SUBJECT: NORTH ANNA UNITS 1 AND 2 - ISSUANCE OF AMENDMENTS RE: IMPLEMENTATION
OF THE REVISED 10 CFR PART 20 (TAC NOS. M87027 AND M87028)

AMENDMENT NO. 178 TO FACILITY OPERATING LICENSE NO. NPF-4-NORTH ANNA UNIT 1
AMENDMENT NO. 159 TO FACILITY OPERATING LICENSE NO. NPF-7-NORTH ANNA UNIT 2

ATTACHMENT TO LICENSE AMENDMENT NO. 178

ATTACHMENT TO LICENSE AMENDMENT NO. 159

6. Figure 5.1-1 Map Defining Unrestricted Areas for Radioactive Gaseous and Liquid Effluents

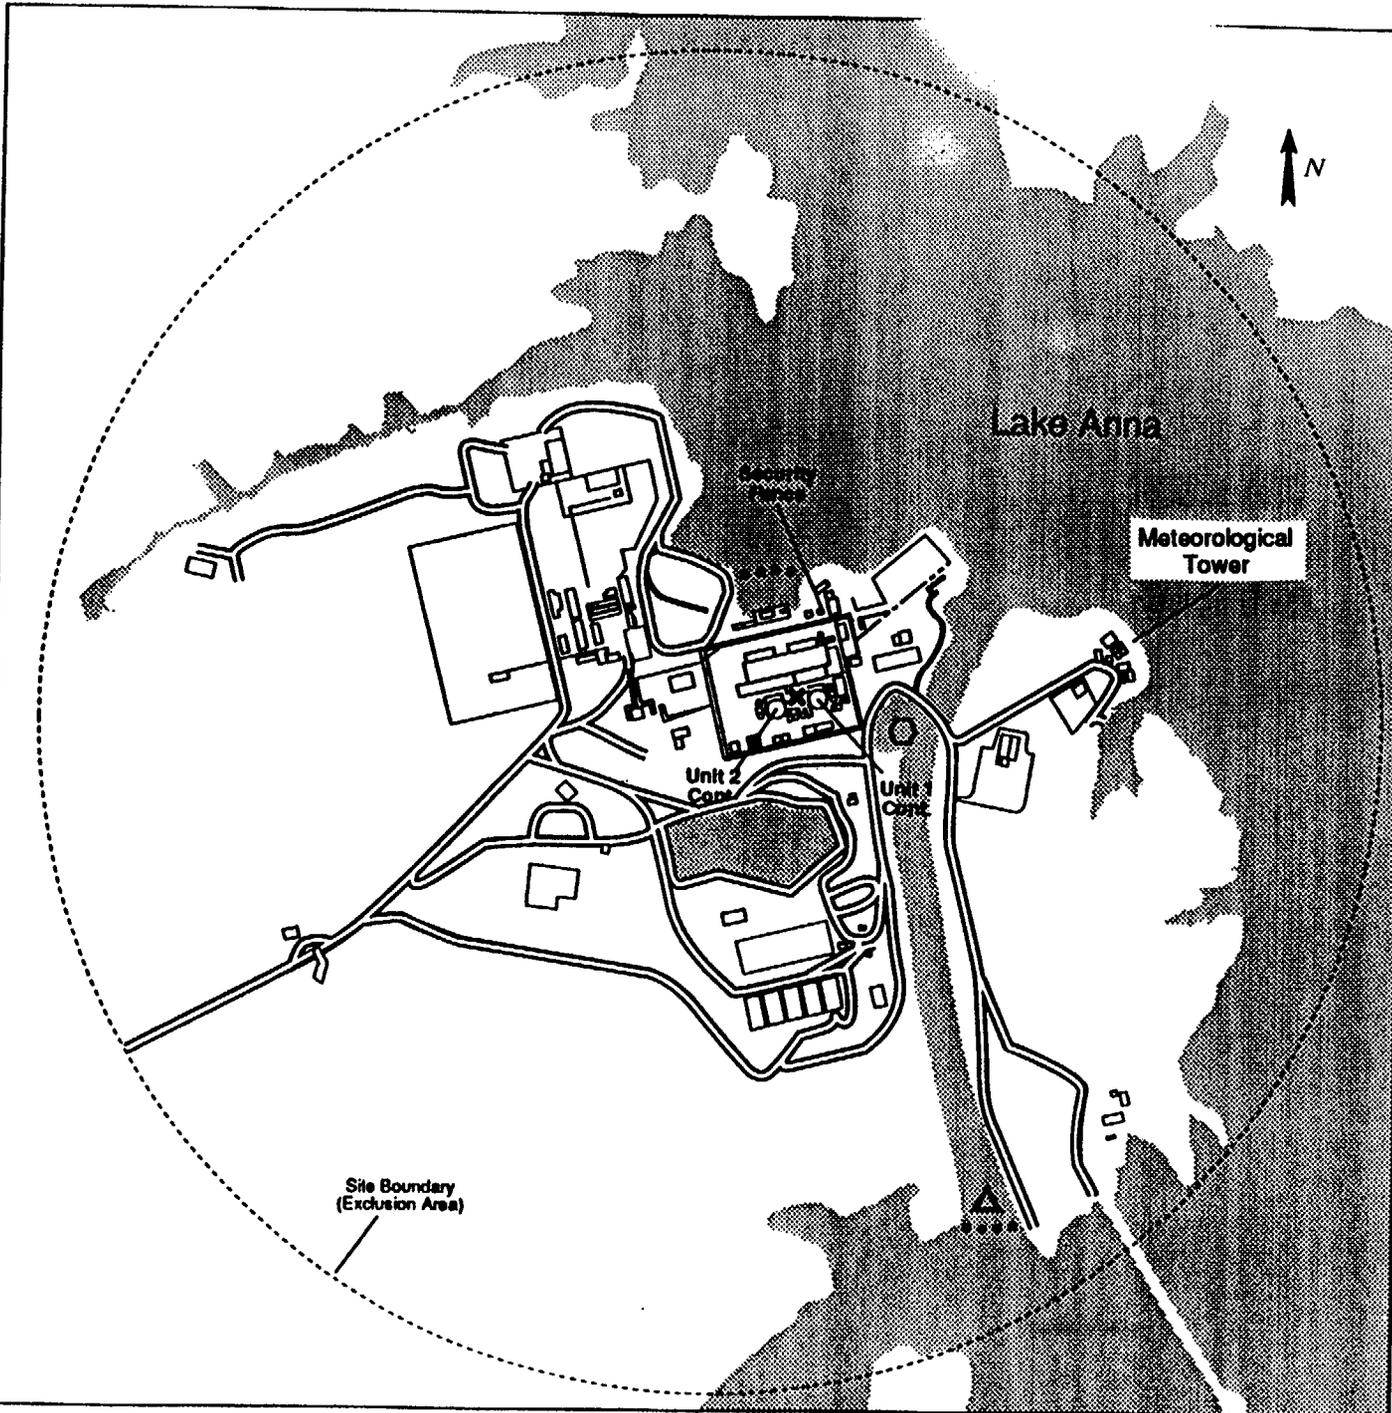
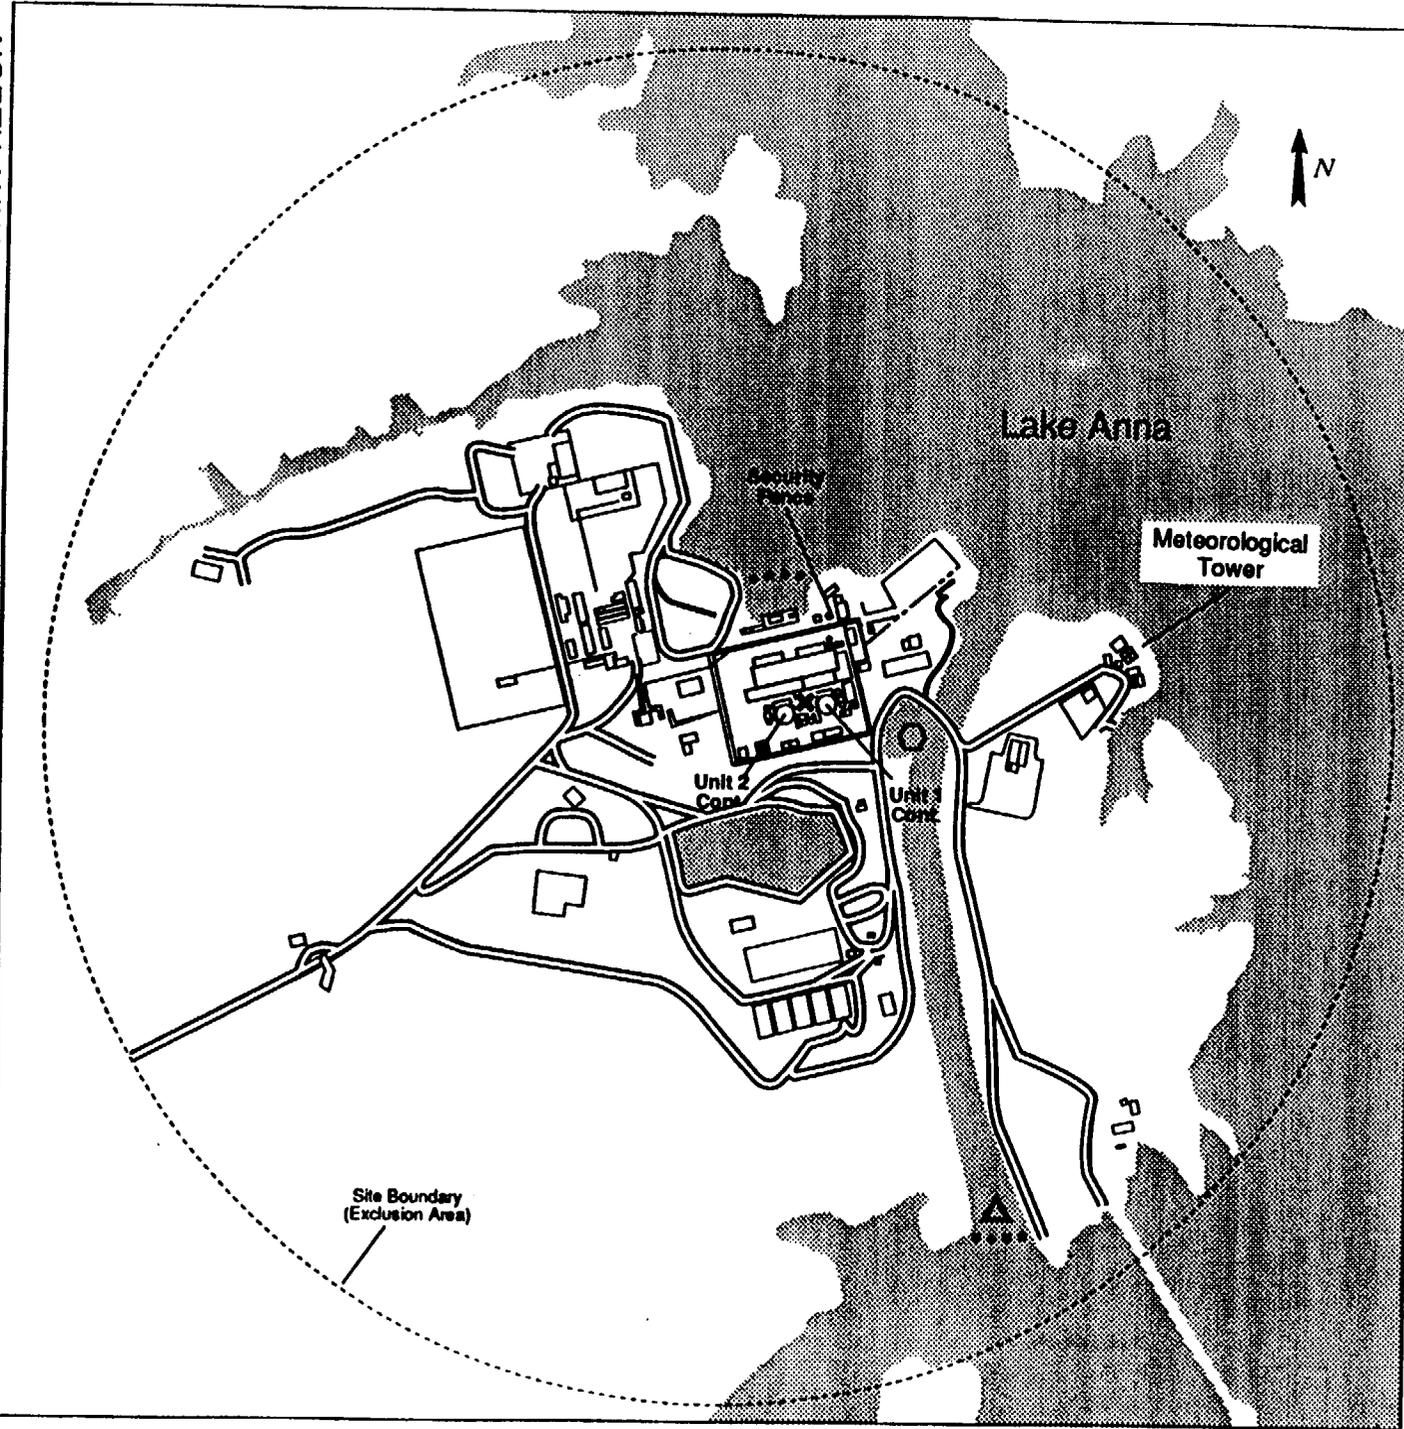
The licensee has proposed to revise this figure to show that the unrestricted area for gaseous effluents is at or beyond the site boundary rather than at the security fence.

The change is administrative in nature and is acceptable.
